17 June 2021

Re: Siasconset Beach Preservation Fund (SBPF) Remediation Plan

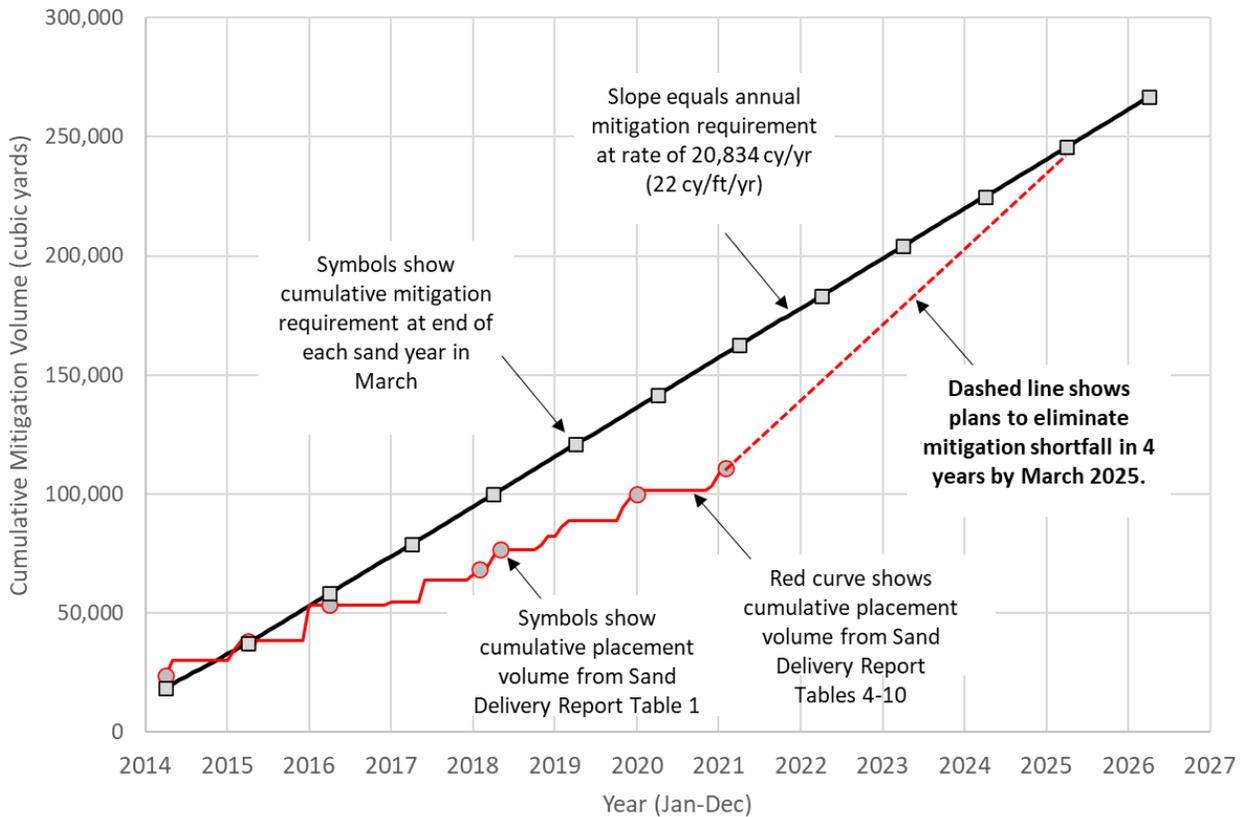
Given that the mitigation requirement was last met over five years ago in March 2016, there is urgency to make up the shortfall. Ideally the shortfall could be made up immediately. But to make up the shortfall within 1 year, SBPF would have to place nearly 68,000 cy in the current year (20,834 cy annual requirement plus 47,000 cy catch up). Among other issues, we recognize that unless sand is barged to the site, placement of 68,000 cy in one year by the truckload would be tremendously disruptive to the community.

As a result, we believe a more realistic remediation plan should balance the need for greater annual sand volumes with the desire to limit the number of truckloads of sand. We also think it important to keep the placement volumes below the historic maximum of 39,204 cy so that it is clear that the plan is achievable.

We therefore propose a 4 year catchup plan. The 4-year catchup plan would require annual placements in the next four years of 32,584 cy. Of this, 20,834 cy would meet the existing annual requirement while the additional 11,750 cy (each year for 4 years) would count toward the catchup. After four years, the annual placement would revert to the 20,834 cy. The remediation plan is illustrated graphically in the figure below.
